RE: REVISED C-108, SWD APPLICATION
CHOATE DAVIS 13 STATE #3- API#: 30-015-45444
Unit Letter "D" Section 13 T18S R27E
Eddy County, New Mexico

CHOATE DAVIS 13 STATE SWD #3

APPLICATION FOR AUTHORIZATION TO INJECT REVISED

NOTICE OF OBJECTION WITHDRAWAL

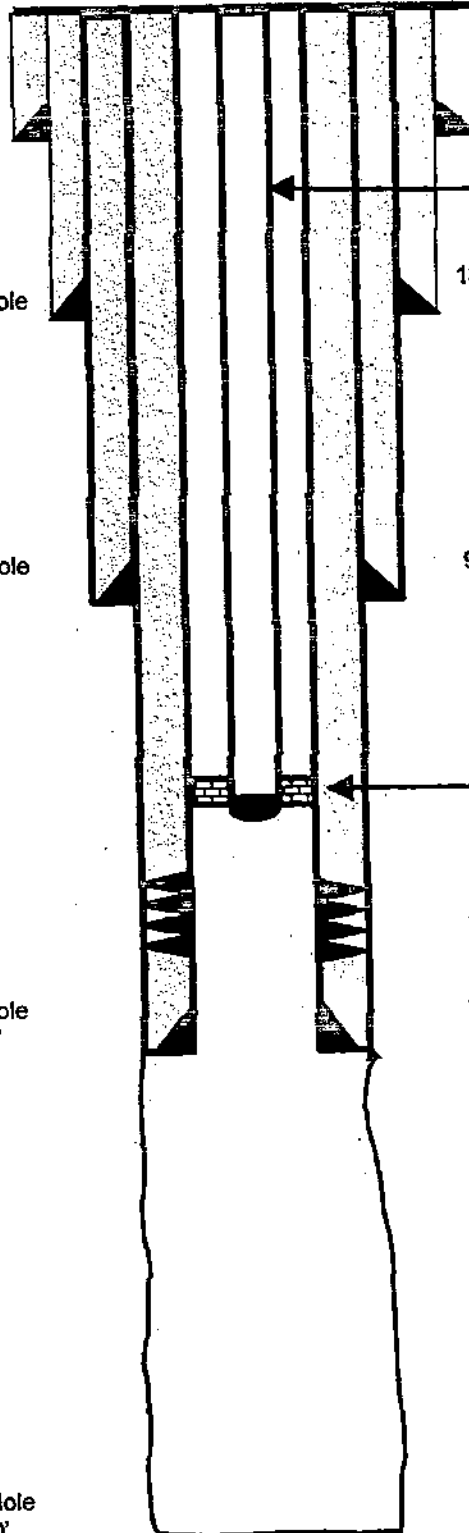
On December 19, 2018, V-F Petroleum Inc. notified the NMOCD of their objection to the original SWD application. Since then, Lime Rock Resources II-A, L.P. and Jerry Gahr with V-F Petroleum Inc. have agreed that Lime Rock would not perforate above the top of the Wolfcamp at about 6500', and V-F Petroleum's objection would be withdrawn. This eliminates the Lower Abo from any injection water.

Since Lime Rock has agreed not perforate above the top of the Wolfcamp at about 6500', V-F Petroleum hereby withdraws our objection to Lime Rock's revised SWD application. This eliminates the Lower Abo from any injection water.

Revised: 2/6/19
M. Pippin

SWD NP IPC AS-A PKR @ 6400'

Wolfcamp Perfs
~6500'-7530'
